Project: **GROSSE POINTE PUBLIC SCHOOL SYSTEM**
Richard Elementary School
Restroom Remodeling – Phase Two

Project No.: 9113

Addendum Number: 2

Project No. 9113 A20

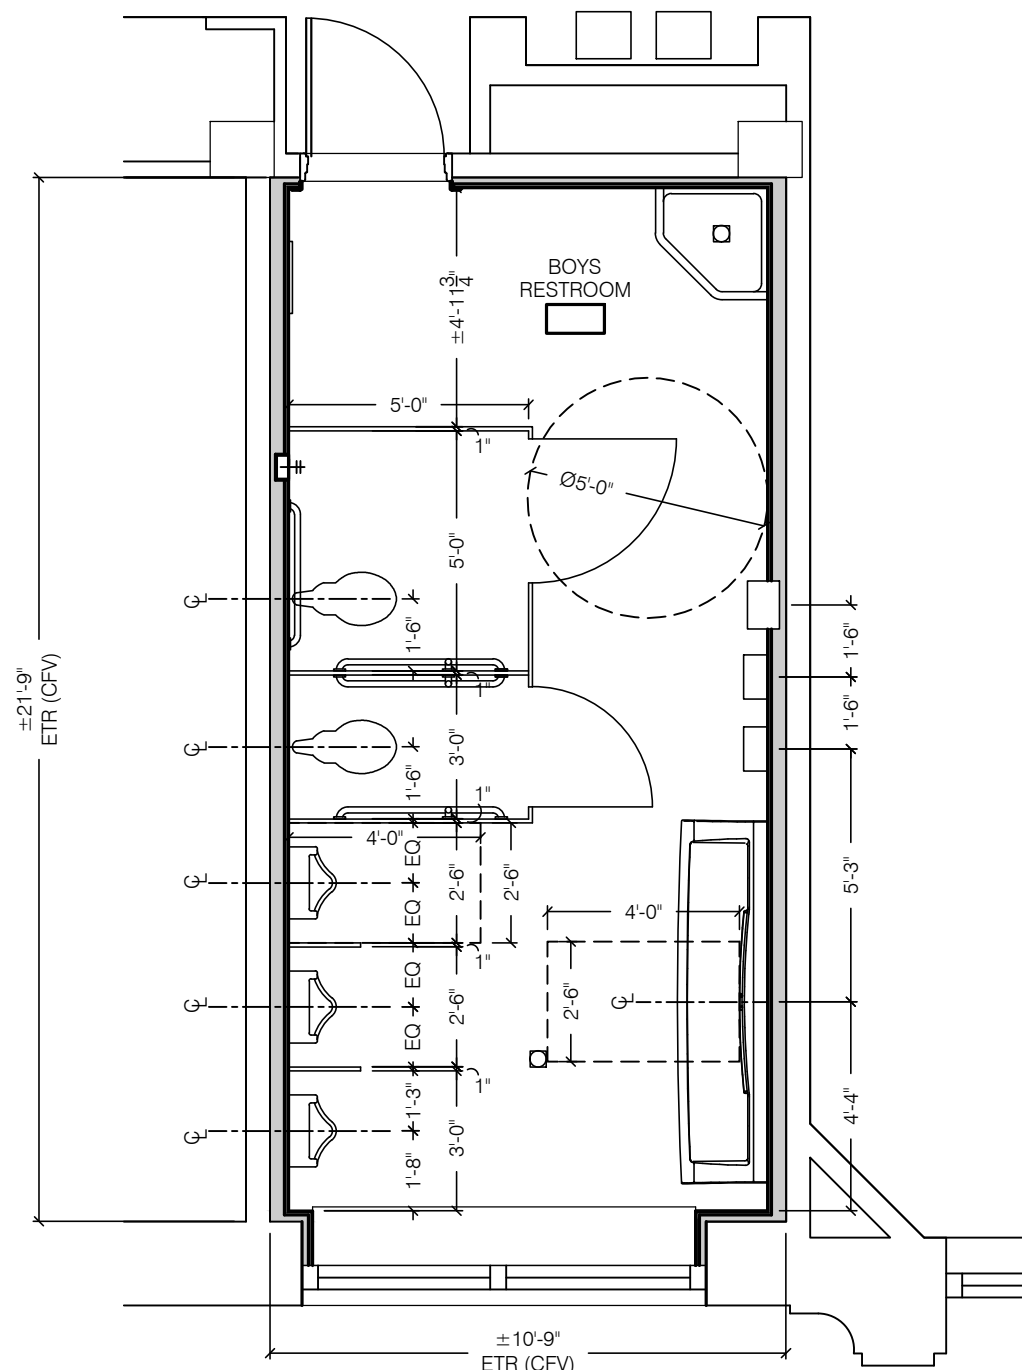
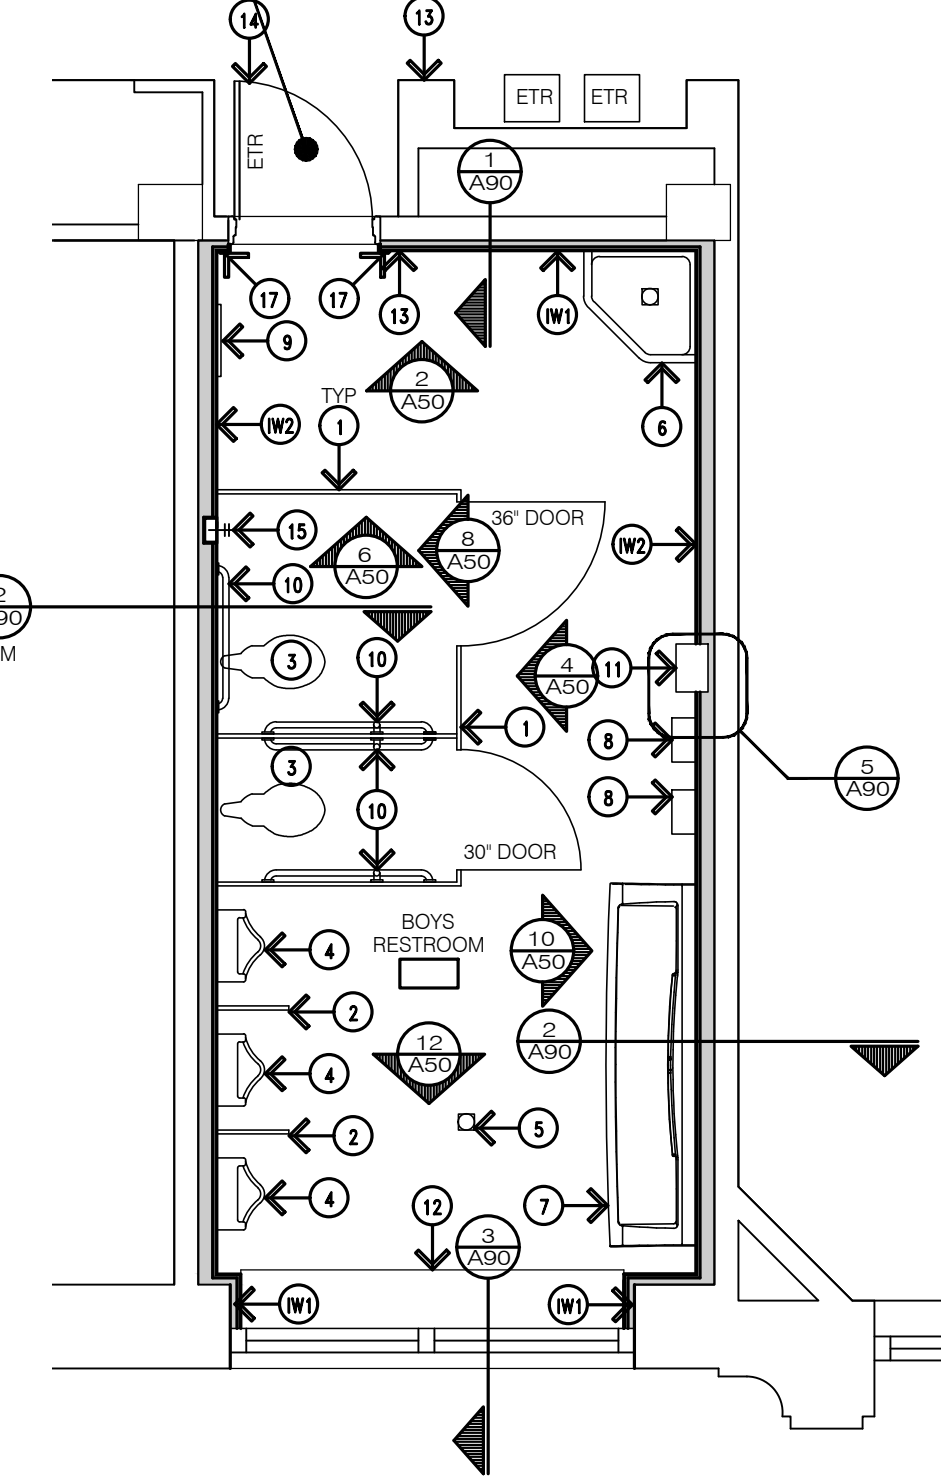
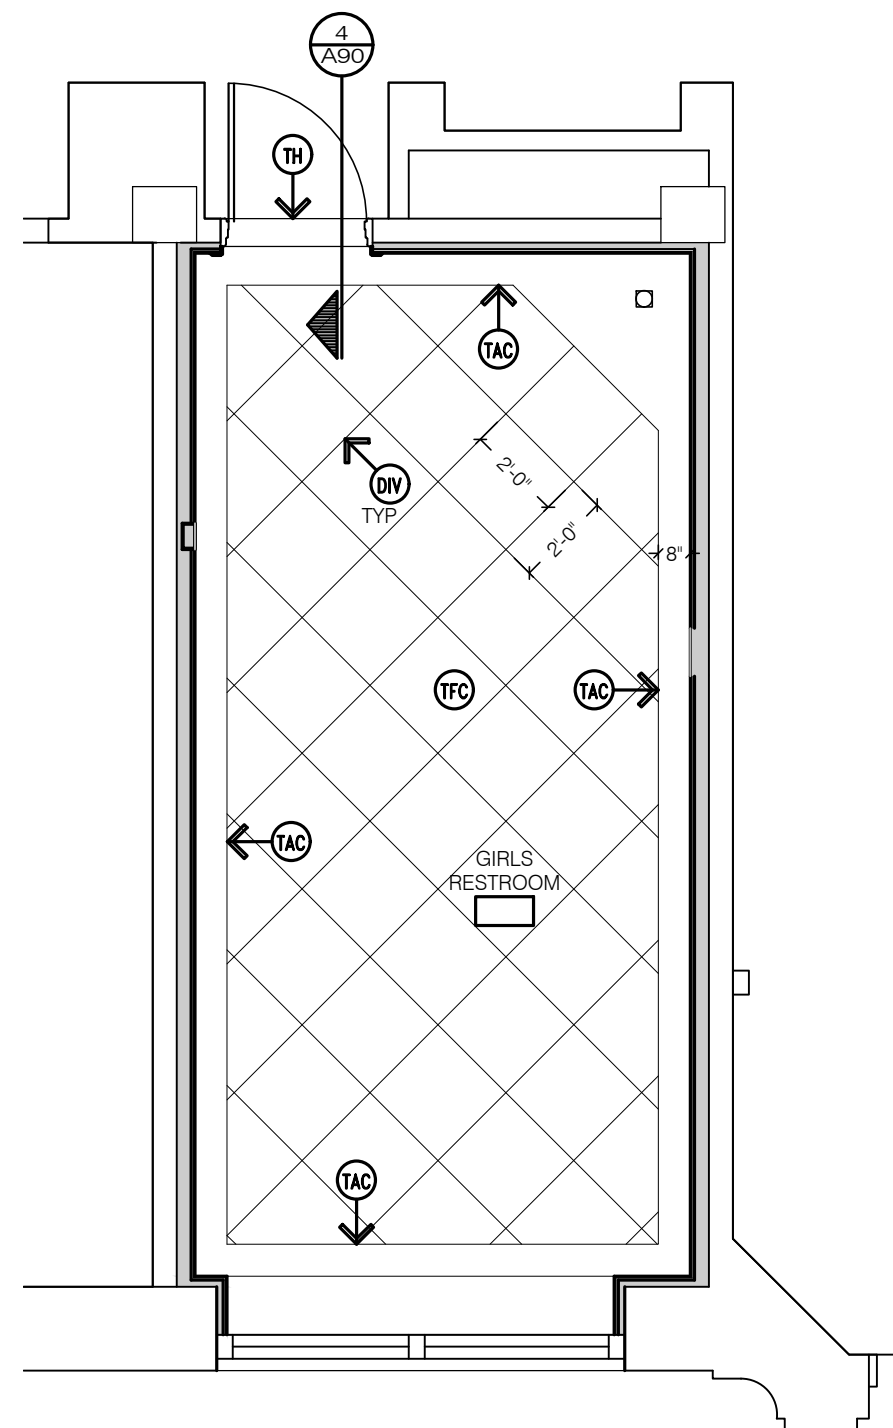
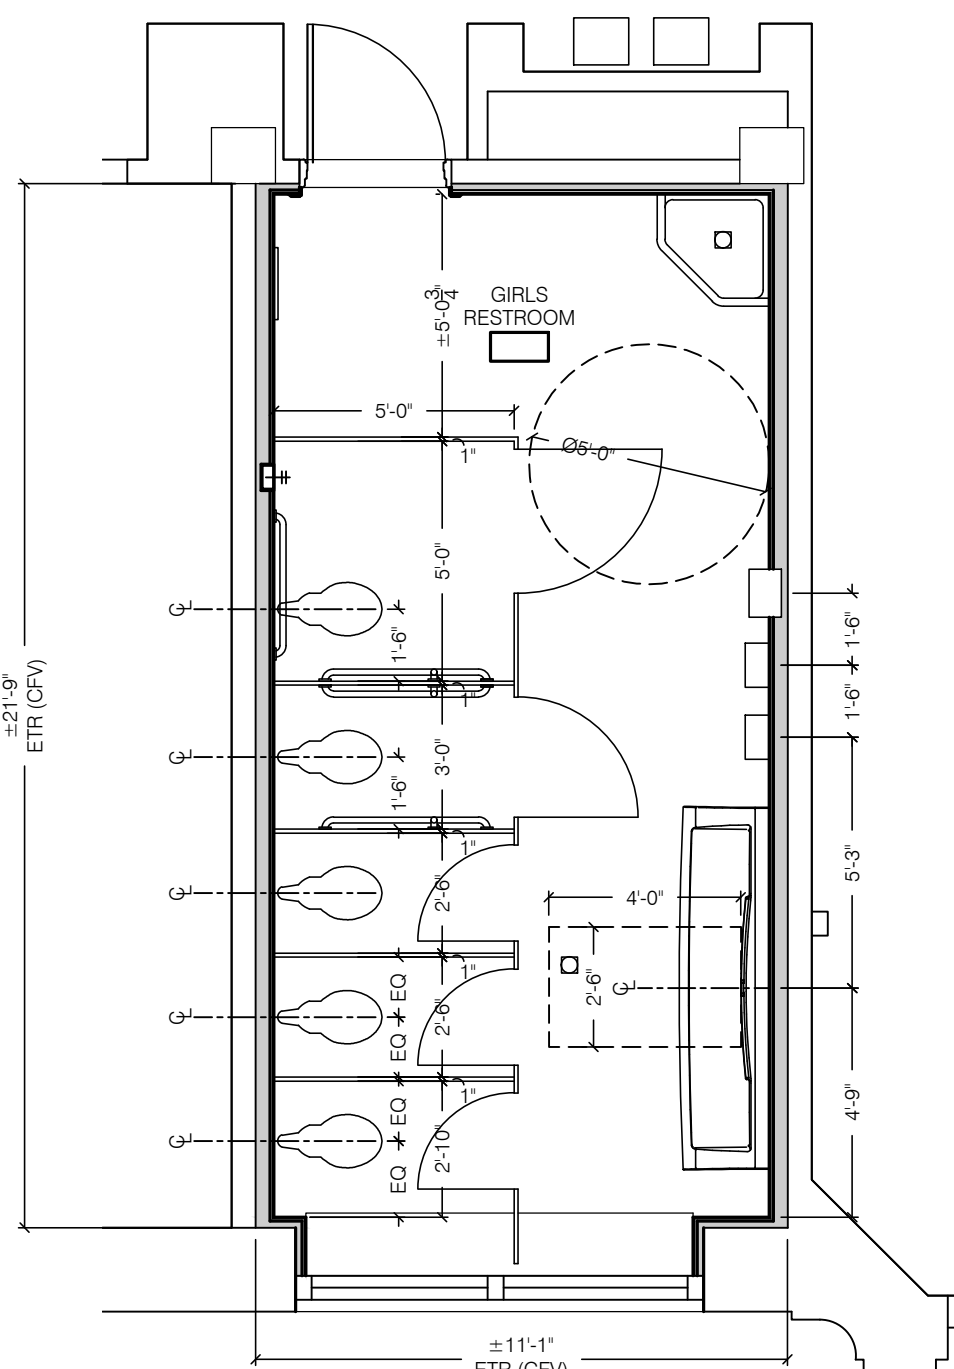
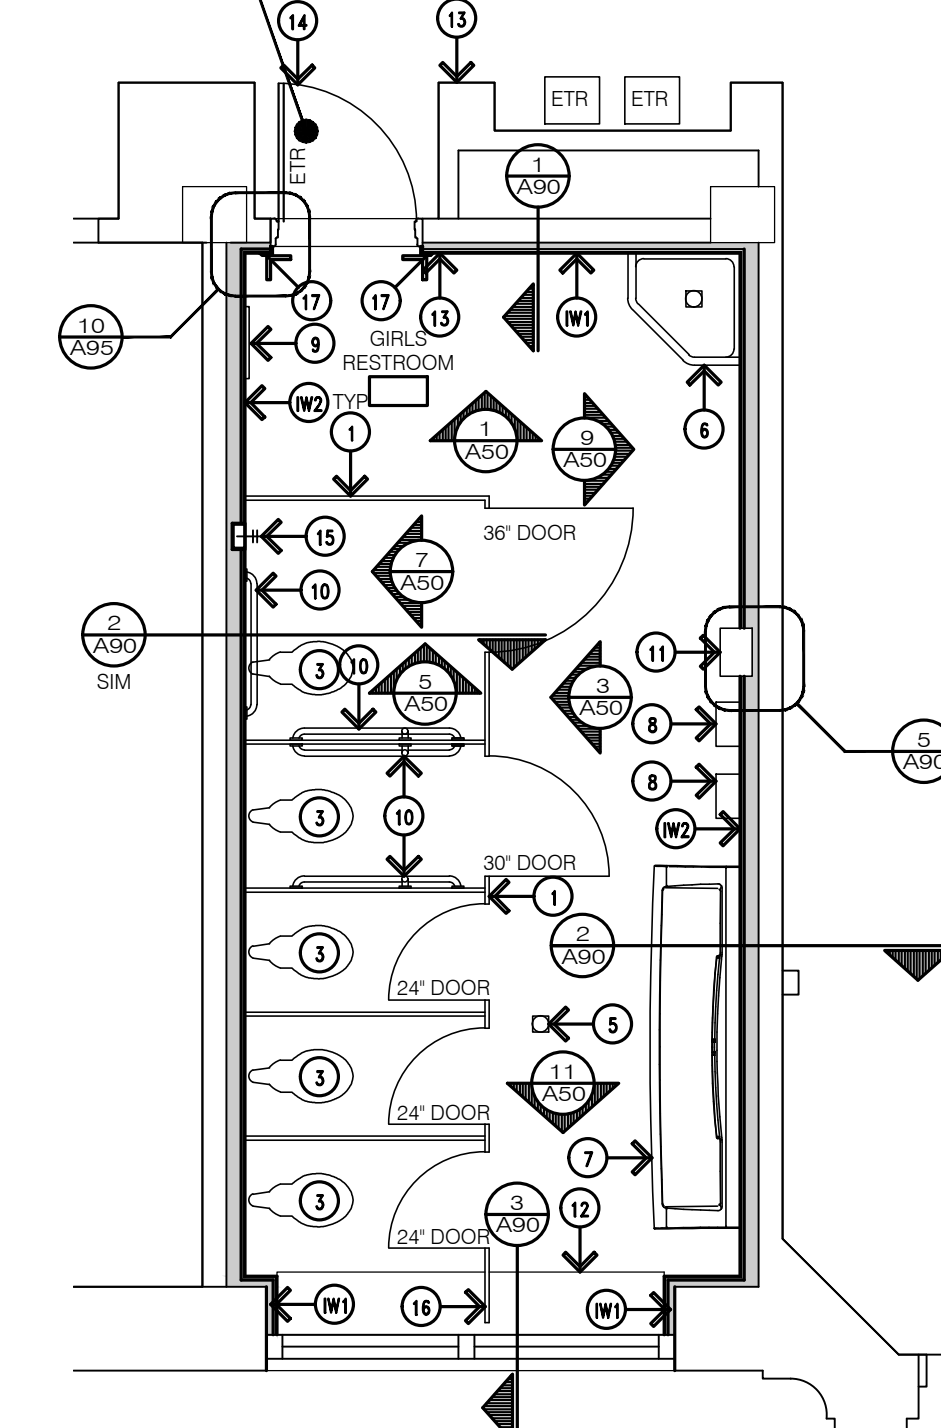
CHANGE: Drawing Note 4.
FROM: Wall mounted urinal with automatic flush valve, mounted with rim at 17" A.F.F.
Refer to mechanical for further information. Provide concealed carrier with floor supported stanchions.

TO: Wall mounted urinal with automatic flush valve, mounted with rim at 12" A.F.F.
Refer to mechanical for further information. Provide concealed carrier with floor supported stanchions.
